No. 207

Piper Aircraft Corporation

SUBJECT: Oil Quick Drain Valve Assembly, Part Number 12956-04

MODELS AFFECTED: All Models incorporating the use of the above valve

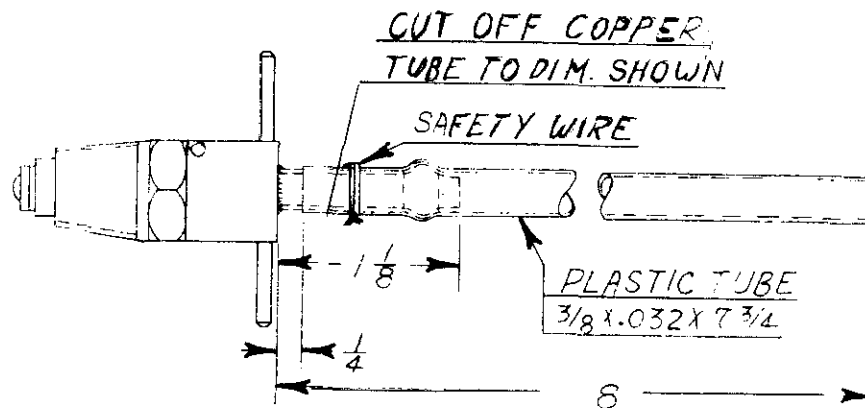
It has been brought to our attention that vibration has caused the quick oil drain valve to break at the rubber washer seal and also at the point where the copper drain tube is soldered.

To eliminate this condition it is recommended that the valve be modified in accordance with the sketch shown below. The plastic tube may be obtained from the Service Department of the Piper Aircraft Corporation on a No Charge basis. This plastic tube will be furnished on a No Charge basis until June 1, 1954.
